WRITTEN STATEMENT OF CONDITIONS

PRELIMINARY PLAT
GOLDEN GROVE

LOTS 1-18 & 19X BLOCK 1,
LOTS 1 - 10 BLOCK 2,
LOTS 1-6, 7X, 8-22 BLOCK 3,
LOTS 1 - 7 BLOCK 4,
12.424 ACRES OF LAND
BEING

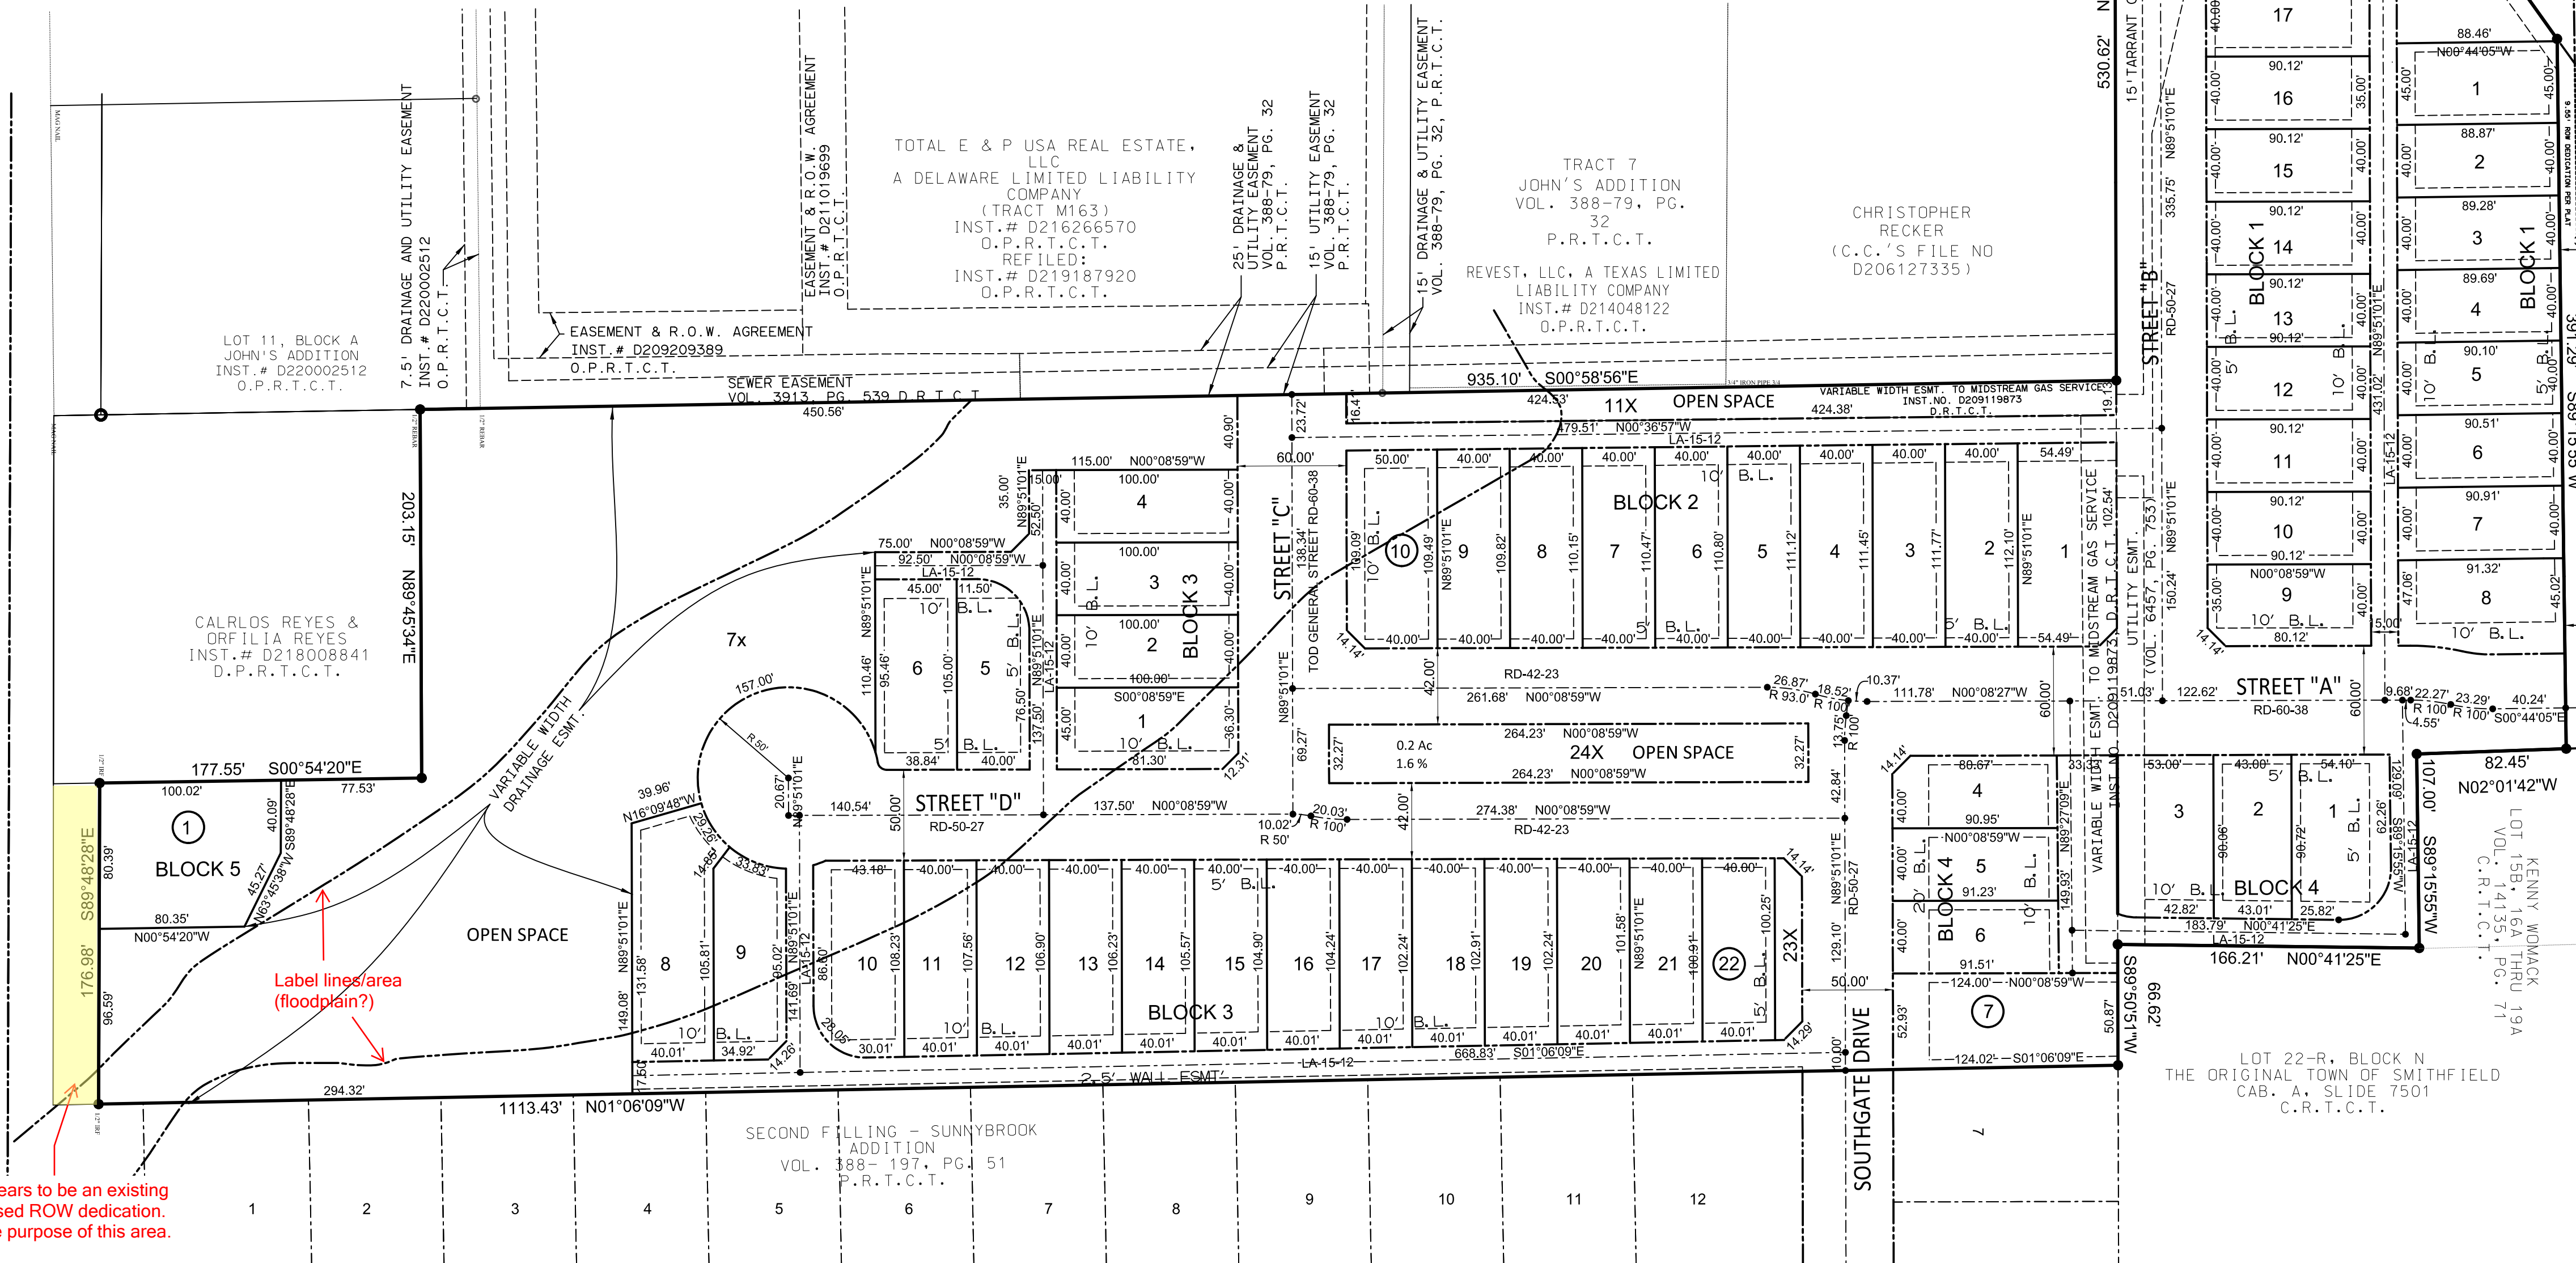
1. There is an unlabeled area on Cardinal Lane adjacent to Lot 1 Block 5 and Lot 7X Block 3 that appears to be an existing or proposed right-of-way dedication. Label the purpose of this area. See the marked-up print for more information. *NRH Subdivision Regulations §110-232 (Street right-of-way dedication) and §110-257 (Street right-of-way dedication)*

2. Label the floodplain lines and area on the plat. *NRH Subdivision Regulations §110-202 (Requirements for preliminary plat drawings – floodplain features)*

3. Once engineering is further along for the channel and new floodplain limits are established, a 10-foot erosion setback easement will be required at the top of the channel. *NRH Subdivision Regulations §110-201 (Requirements for all plat drawings – easements) and §110-262 (Drainage improvement requirements)*

4. Lots in the current effective floodplain will require a minimum finished floor elevation to be labeled on the plat. A flood study is required to establish the base flood elevation. The required finished floor elevation is at least 18 inches above base flood elevation. *NRH Subdivision Regulations §110-262 (Drainage improvement requirements)*

5. Label the area of the lots in square feet. *NRH Subdivision Regulations §110-203 (Additional requirements for plat drawings – lot areas)*

Will require flood study

Lots in the current effect floodplain will require minimum FFE to be labeled on Plat. Flood study to establish BFE. FFE min 18" above BFE. At building permit stage: 2 elevation certificates will be required for lots with min FFE listed. 1 at formboard stage and 1 at final.

A separate 10' erosion setback easement will be implemented at the top of the channel once engineering is further along and new floodplain limits are established.

GENERAL COMMENTS
- Label the area of the lot in square feet.

A separate watercourse maintenance agreement will be required to accompany the final plat. Staff can provide a draft version to developer for reference.
